ADDENDUM TO SOLICITATION/OFFER AND AWARD

1. ADDENDUM 2	2. EFFECTIVE DATE November 1, 2011	3. SOLICITATION NUMBER ITB 11-4	4. SOLICITATION DESCRIPTION Appleton Museum Glass Project
5. ISSUED BY: COLLEGE OF CENTRAL FLORIDA STEWART E. TRAUTMAN, JR., DIRECTOR OF PURCHASING 3001 SW COLLEGE ROAD FOUNDERS HALLS/BLDG. 1/ROOM 101 OCALA FLORIDA 34478-1388 TELEPHONE: (352) 873-5815 FAX: (352) 291-4423		6. MAIL TO: COMPANY NAME: COMPANY ADDRESS: TELEPHONE: FAX:

**ADDENDUM
 31 OCTOBER 2011
 APPLETON MUSEUM GLASS PROJECT
 COLLEGE OF CENTRAL FLORIDA
 OCALA, FLORIDA
 BID # 11-4**

Sheet No: **A100.2**

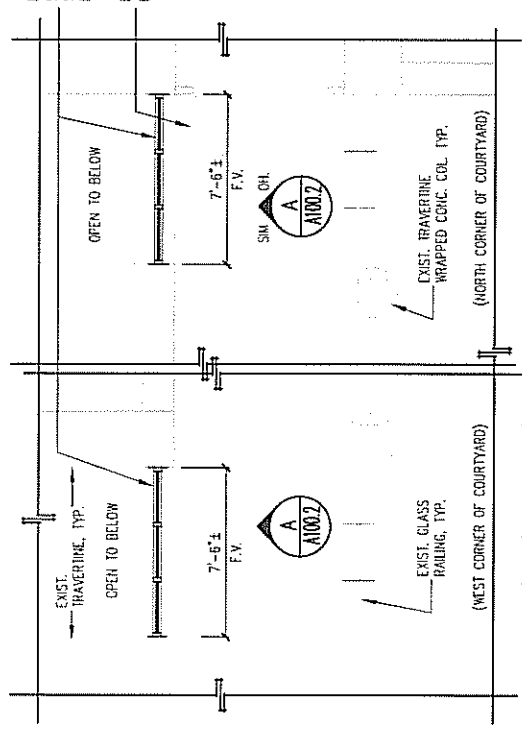
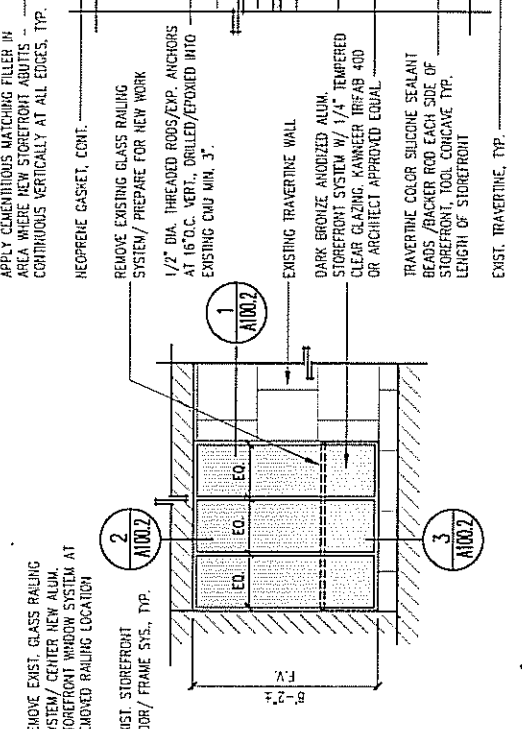
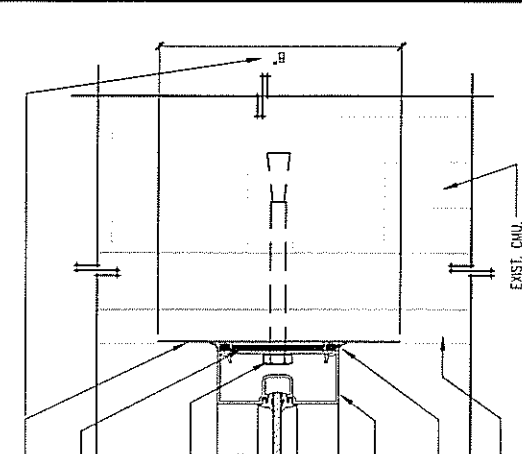
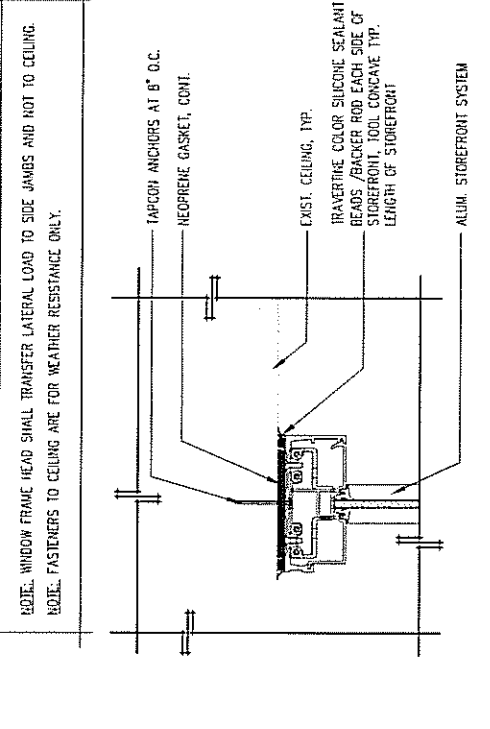
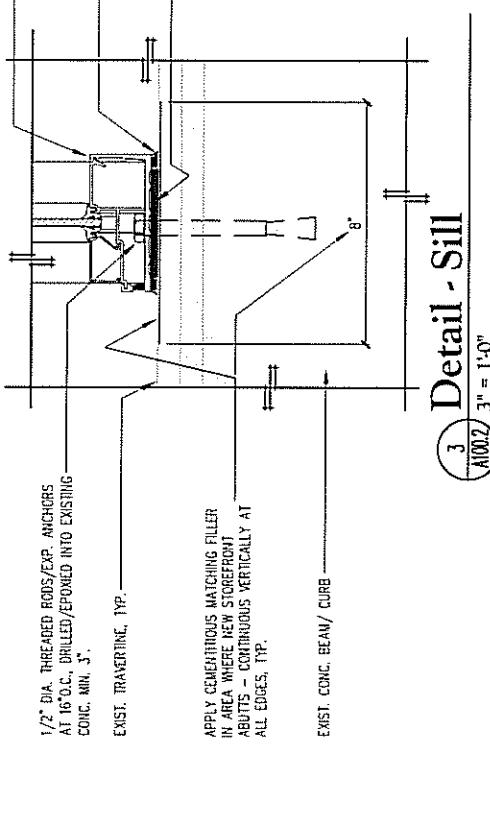
06	<p>Question: According to local glass suppliers 1/2" tempered glass is only available up to 84" wide, the three center pieces exceed this width. The glass would need to be installed in four pieces or shipped from the west coast. Please inform us on how to proceed.</p> <p>Answer: It is permissible to subdivide the center bay into four panels, in lieu of three panels.</p>	Clarification
07	Two new glass openings shall be provided on the second floor per attached detail sheet A100.2	Drawings Sheet A100.2
